PACKARD MOTOR CAR COMPANY

**Counselor**

FEBRUARY, 1954

Power Steering Pump Bracket and Belt Adjusting Tool

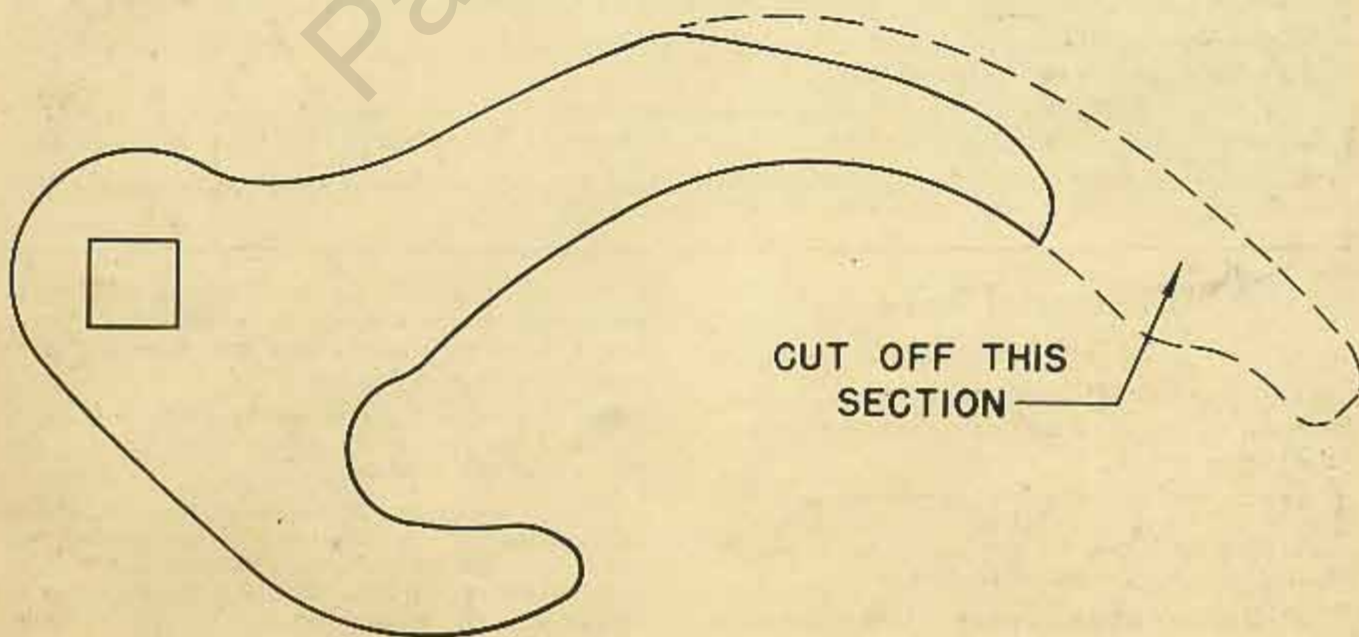
The power steering pump bracket assembly has been redesigned to prevent breakage and started in production with the 54th Series cars.

To adjust the belt tension on a power steering pump which has the new bracket, it will be necessary to rework the adjusting tool "PK-12" by cutting and grinding off the section indicated by the dotted line as shown on the illustration.

The new bracket assembly is available as service replacement for the 25th and 26th Series cars and may be ordered under Part No. 455321.

The reworked tool can still be used with the old type bracket.

Throttle Cross Shaft to Carburetor Rod Tool

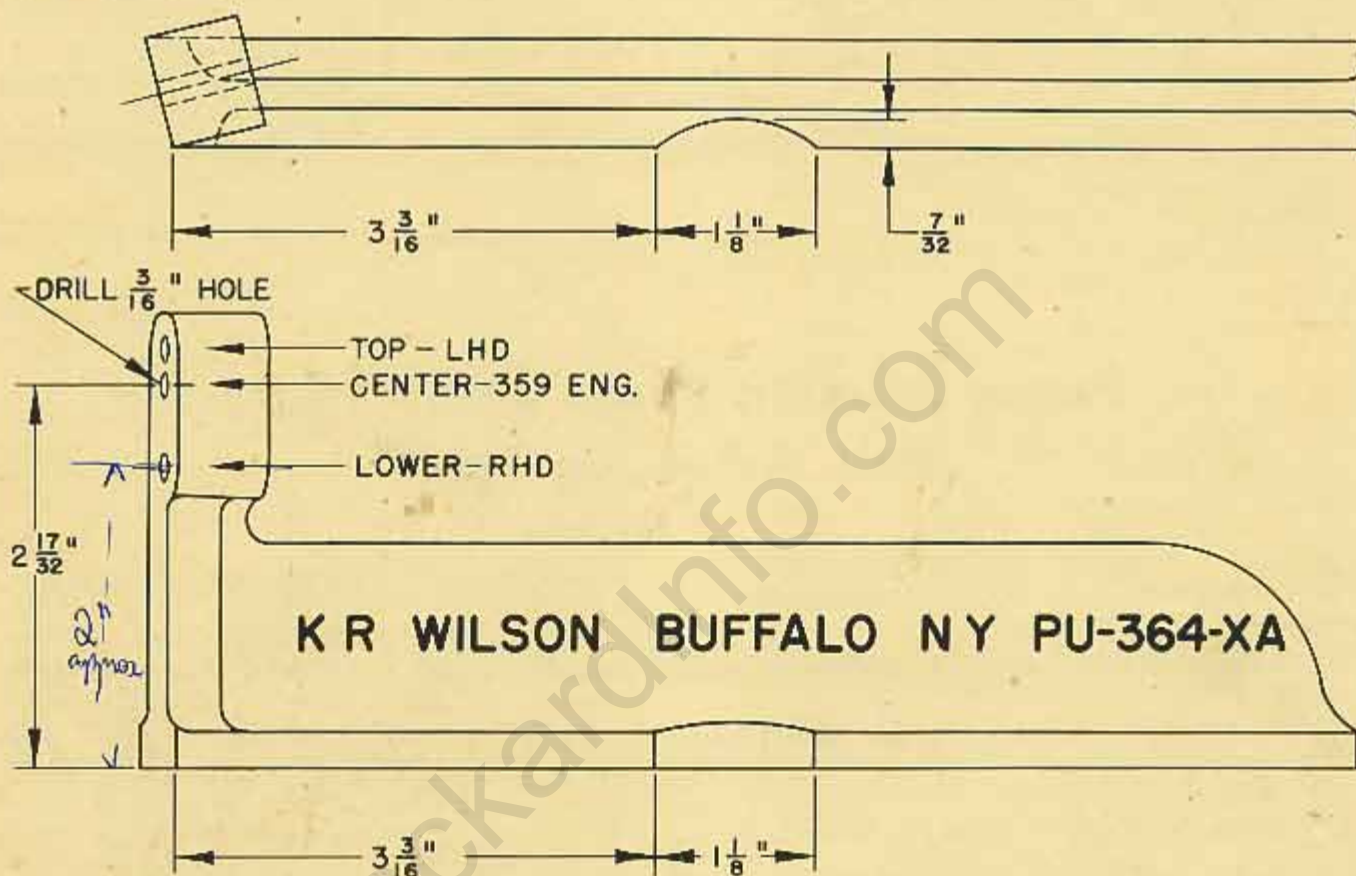
The throttle cross shaft and carburetor throttle rod has been changed slightly on the 359 cu. inch engine.

Because of the throttle linkage change, it will be necessary to rework your present throttle adjusting gauge PU-364 to properly make this adjustment on all 54th Series cars that are equipped with the 359 cu. in. engine and Ultramatic Drive.

Using the measurements on the illustration, carefully drill a $\frac{3}{16}$ " hole through the gauge as shown.

Grind out a section from the forward side of the gauge base $1\frac{1}{8}$ " long and $\frac{7}{32}$ " deep $3\frac{3}{16}$ " from the end of the gauge as shown on the illustration.

Do not use .050" shim stock under the gauge with either the old or new gauges when setting the throttle linkage on a 359 cu. in. engine as described on page 10 of Volume 27, No. 2, February 1953 Service Counselor.

It is suggested that the $\frac{3}{16}$ " gauge holes be identified by stamping the following information on the back side of the gauge "TOP-LHD," "Center-359 Eng.," "Lower-RHD."

Fig. 1

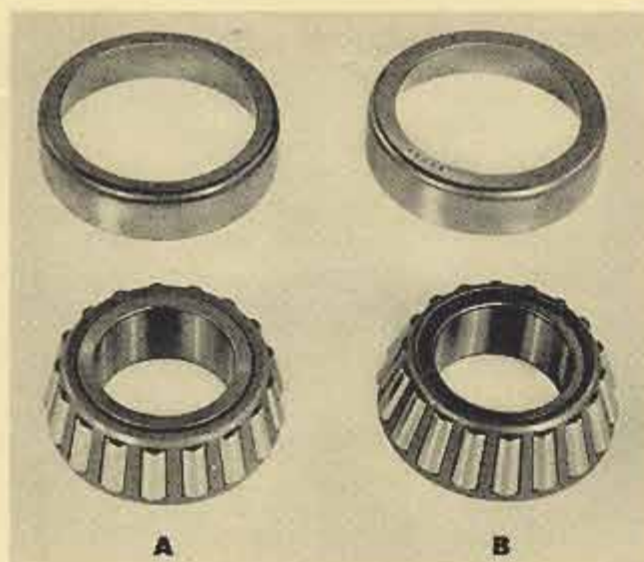
1. Fig. 1 shows the 25° rear pinion bearing and cup indicated by "A." The 40° rear pinion bearing and cup is indicated by "B." Note the difference in the angle of the rollers, also that the flat end section is wider on the 40° bearing cup.

Fig. 2

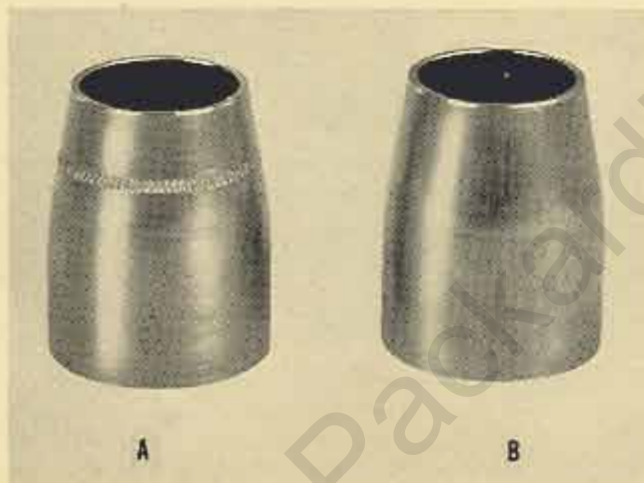
Fig. 2 shows the pinion bearing sleeve used with the 25° bearing indicated by "A." The sleeve used with the 40° bearing is indicated by "B." The knurled section on the 25° bearing sleeve (A) is provided for identification purposes.

It is permissible to use either the 25° or 40° rear pinion bearings in the 54th Series differentials provided the proper sleeve is also used.

Fig. 3

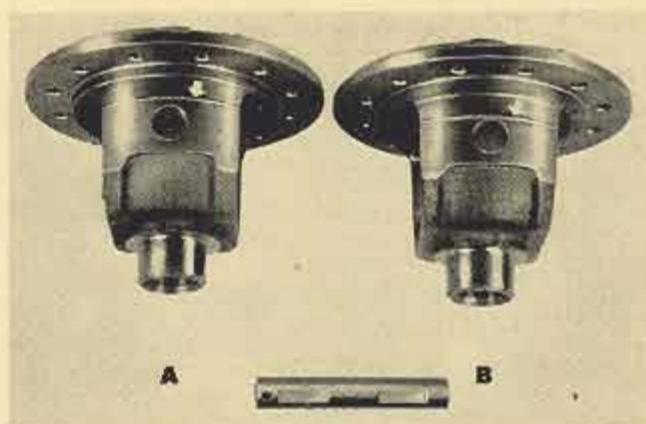
2. The diameter of the differential case and the length of the differential pinion pin have been reduced to allow sufficient clearance for the longer pinion gear. Only those 54th Series differentials that are equipped with the long pinions have the case machined to a smaller diameter and have the slightly shorter pinion pin.

"A" shows a differential case that has the diameter near the pinion pin hole machined down to give

clearance for the long pinion gear. Note the ridge indicated by the arrow is approximately $\frac{1}{4}$ " from the pin hole.

"B" shows a differential case that has not had the diameter reduced. Note the ridge indicated by the arrow is quite close to the pin hole.

Ring and pinion gear sets with the long pinion gear teeth *cannot* be used on the differential case "B."

Ring and pinion gear sets either long or short can be used on the differential case "A." Do not use a long pinion pin in differential case "A."
